V2500-A5/D5 PROPULSION SYSTEMS SERVICE BULLETIN

This document transmits Revision 4 to Service Bulletin EV2500-72-0357 and the Initial Issue of the Supplement

V2500-ENG-72-0357

ENGINE – HP TURBINE ROTOR ASSEMBLY – INTRODUCE NEW FIRST STAGE TURBINE BLADES WITH
PROTECTIVE COATING ON THE INTERNAL CAVITIES

Location of the Stage 1 HPT Blade
Figure 1

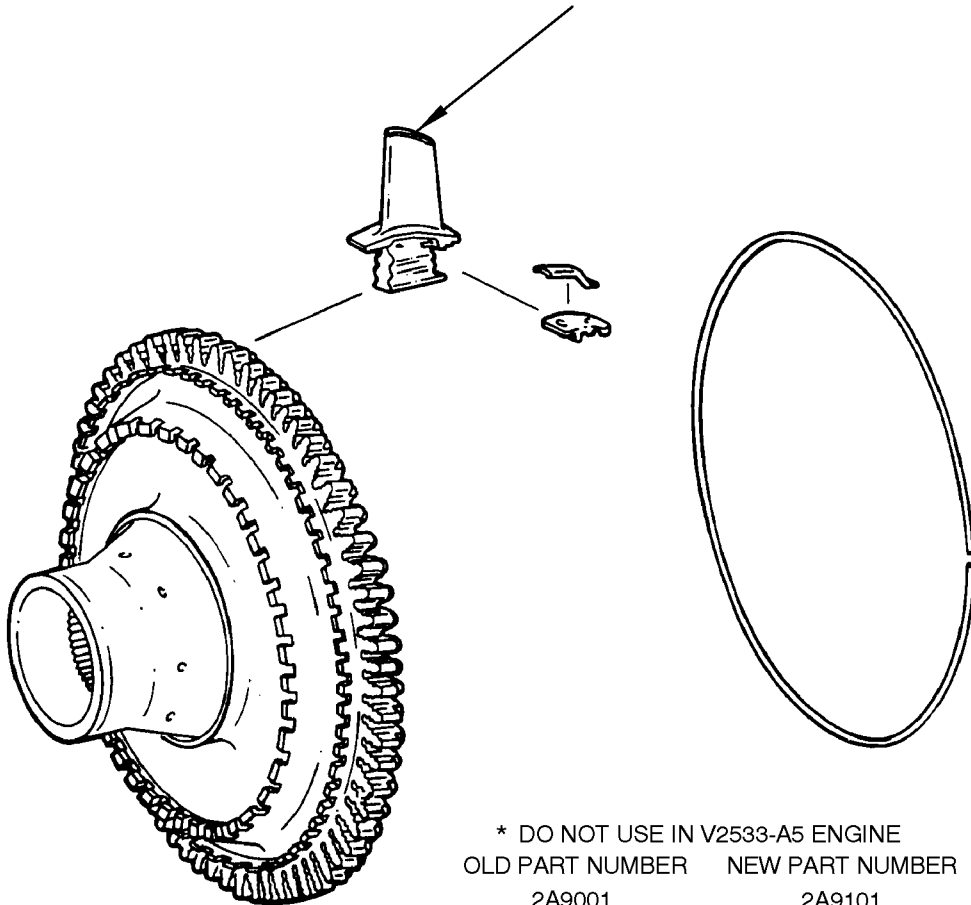
REPLACE THE STAGE 1 HPT BLADE
WITH THE APPLICABLE NEW
STAGE 1 HPT BLADE

* DO NOT USE IN V2533-A5 ENGINE

OLD PART NUMBER	NEW PART NUMBER
2A9001	2A9101
2A2621-004*	2A2621-002*
2A2621-004*	2A2621-003*
2A8321-004*	2A8321-002*
2A8321-004*	2A8321-003*
2A8521-004*	2A8521-002*
2A8521-003	2A8521-005
2A8701-002*	2A8721-001*

- (5) Assembly Procedure
- (a) For V2522-A5, V2524-A5, V2527-A5, V2527E-A5, V2527M-A5, V2530-A5, and V2533-A5 Engines. Replace the Stage 1 HPT Blades (64 off) by the approved procedure given in Reference (4), Chapter/Section 72-45-10, Assembly-01 and Figure 1.

- (b) For V2525-D5 and V2528-D5 Engines. Replace the Stage 1 HPT Blades (64 off) by the approved procedure given in Reference (5), Chapter/Section 72-45-10, Assembly-01 and Figure 1.

Family Tree – Stage 1 Turbine Rotor Assembly
Ref. Catalog Sequence No. 72-45-10. Fig. 01 Item 010
Figure 2

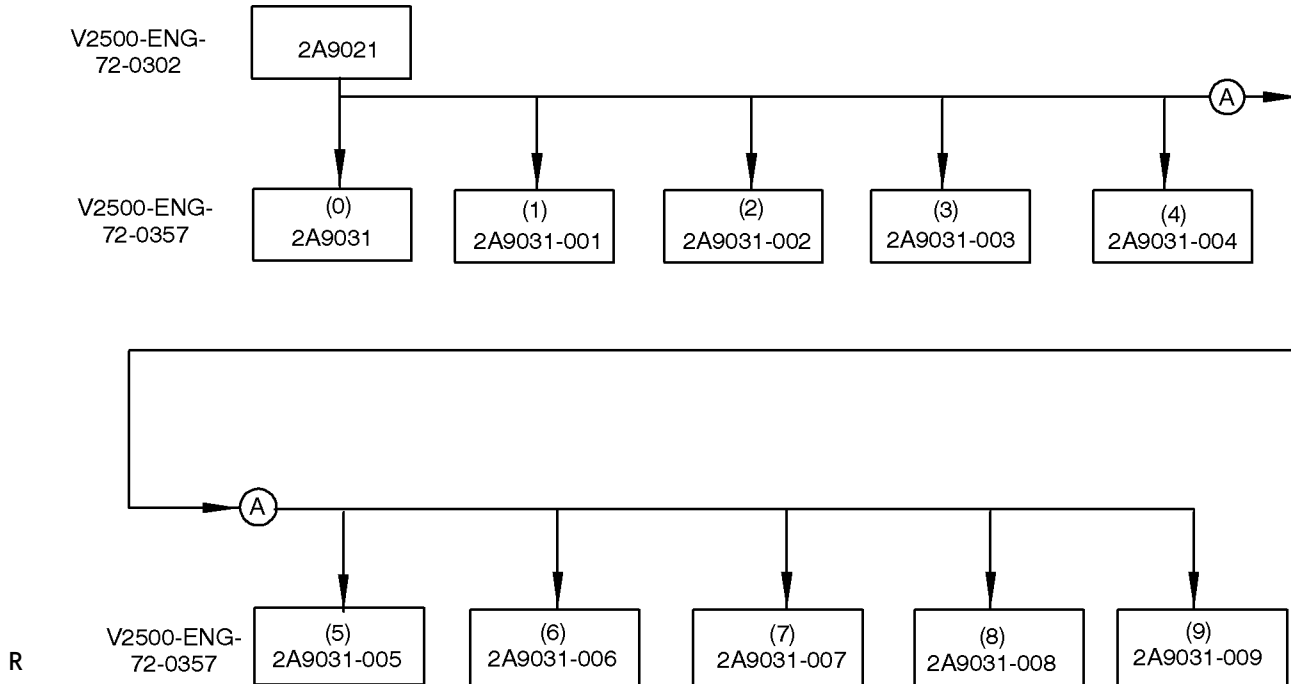
- (0) CONTAINS 64 BLADES 2A9101 (ALL A5/D5 ENGINES)
- (1) CONTAINS 64 BLADES *2A2621-004 (ALL A5/D5 ENGINES EXCEPT A5-33)
- (2) CONTAINS 64 BLADES 2A8521-005 ALL A5/D5 ENGINES EXCEPT A5-33)
- (3) CONTAINS 64 BLADES *2A2621-004 (ALL A5/D5 ENGINES EXCEPT A5-33)
- (4) CONTAINS 64 BLADES 2A8321-004 (ALL A5/D5 ENGINES EXCEPT A5-33)
- (5) CONTAINS 64 BLADES 2A8321-004 (ALL A5/D5 ENGINES EXCEPT A5-33))
- (6) CONTAINS 64 BLADES 2A8521-004 (ALL A5/D5 ENGINES EXCEPT A5-33)
- (7) CONTAINES 64 BLADES 2A8701-002 (ALL A5/D5 ENGINES EXCEPT A5-33)
- (8) MAY CONTAIN ANY MIXTURE OF 2A9101, *2A2621-004, 2A8321-004, 2A8521-004, 2A8521-005, OR 2A8701-002 (ALL A5/D5 ENGINES EXCEPT A5-33)
- (9) MAY CONTAIN ANY MIXTURE OF 2A9101 OR 2A8521-005 (ALL A5/D5 ENGINES EXCEPT A5-33)

* BLADES 2A2621-004 MUST BE USED WITH TOBI DUCT 2A2141-01

Family Tree - Stage 1 HPT Blade
Ref. Catalog Sequence No. 72-45-14. Fig. 01 Item 010
Figure 3

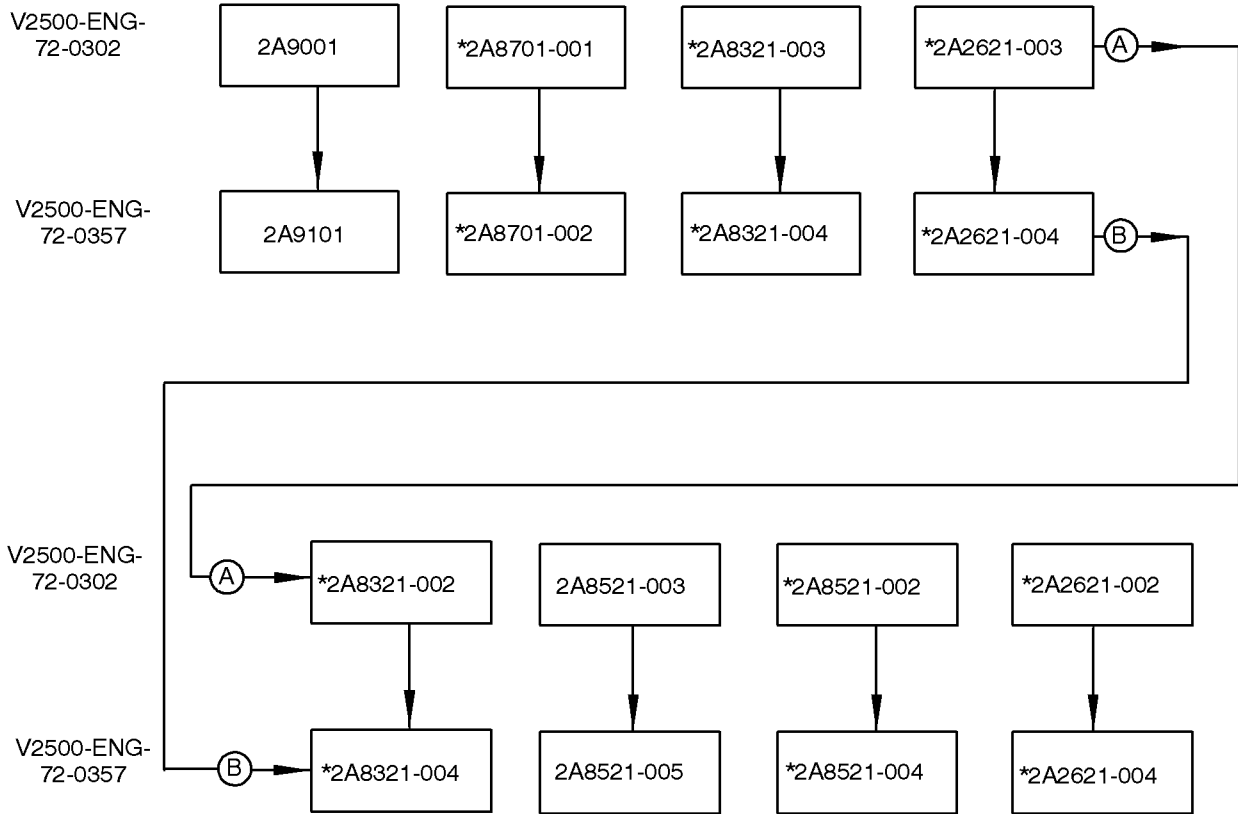
* DO NOT USE THIS BLADE IN V2533-A5 ENGINE
